In re : ENUSTECH.,INC
FCC ID : TT2BHF700
Cover letter

The product is Wireless Handsfree Carkit(Equipment class: Part 15 Low Power Communication Device Transmitter).

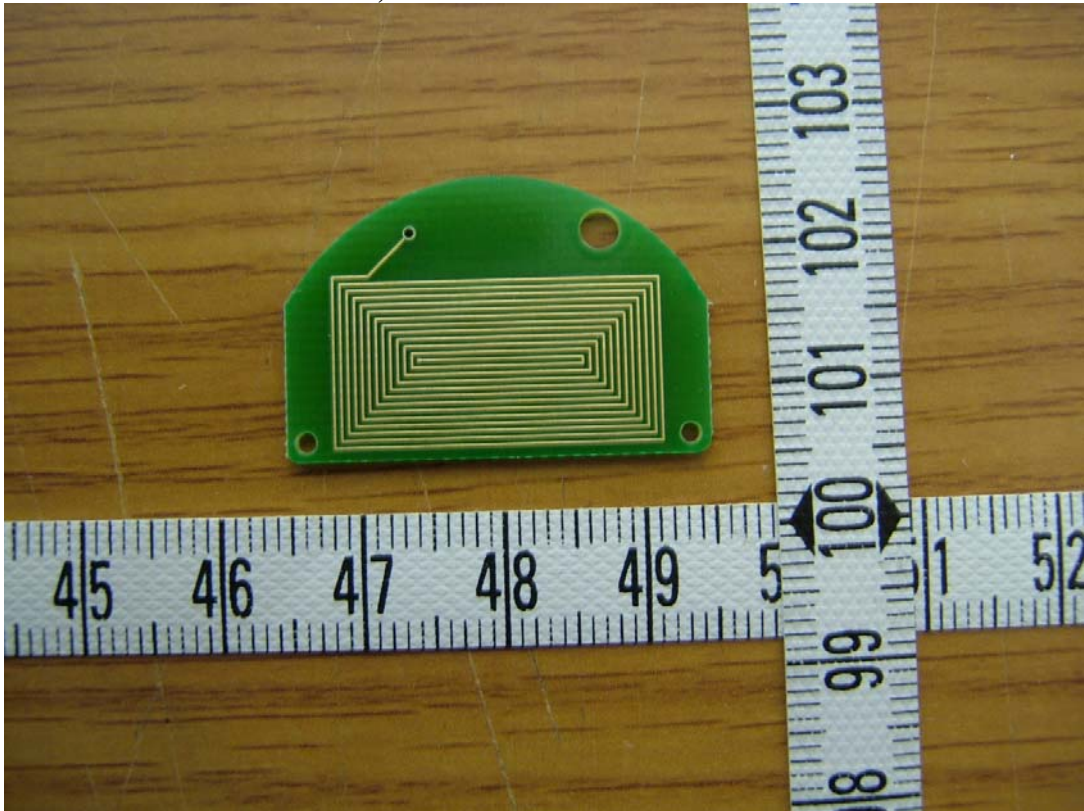
Before	After
FCC ID	TT2BHF700	
Model name	BHF-700	
FMT Antenna	PCB Pattern antenna	Wire antenna
Frequency Band	88.2 – 107.9MHz	88.1 – 107.9MHz

(Old version : PCB Pattern antenna)

(New version: Wire antenna)
